INCH-POUND
MIL-A-18001J
AMENDMENT 2
13 March 1989
SUPERSEDING
AMENDMENT 1
7 December 1987

ANODES, CORROSION PREVENTIVE, ZINC;
SLAB DISC AND ROD SHAPED

This amendment forms a part of MIL-A-18001J, dated 25 November 1983, and is approved for use by all Departments and Agencies of the Department of Defense.

FIGURE 10. ZEP heat exchanger slab."

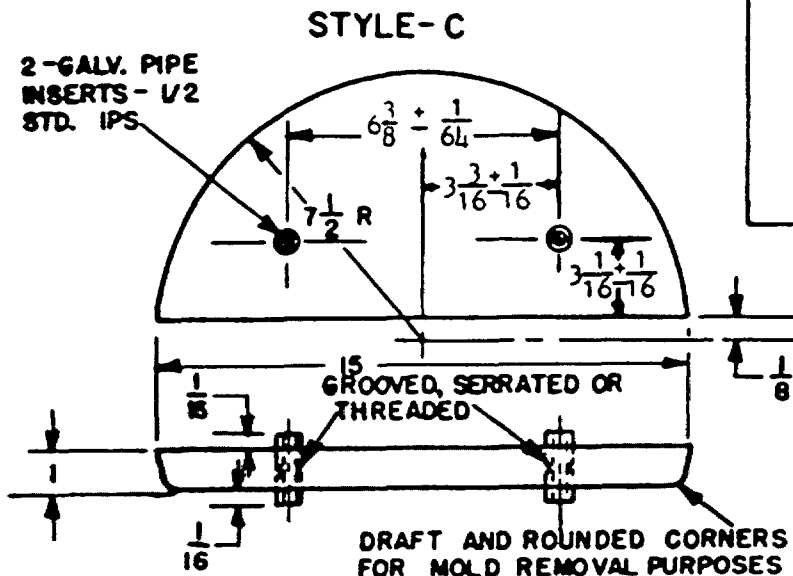
FIGURE 10: Delete and substitute.

Style B

D - Diameter in inches ± 1/8	Approximate Weight (pounds)	Surface area (in ²)
11	24	130
9	16	92
6	7.1	47
5	4.9	36
4	3.19	26
3	1.78	16
2	0.79	9

Style A - Square slab
Style B - Circular slab
Style C - Semi-circular slab

Approximate weight 23 pounds.

1. All dimensions are in inches.
2. Tolerance other than as shown will be plus or minus 1/8.
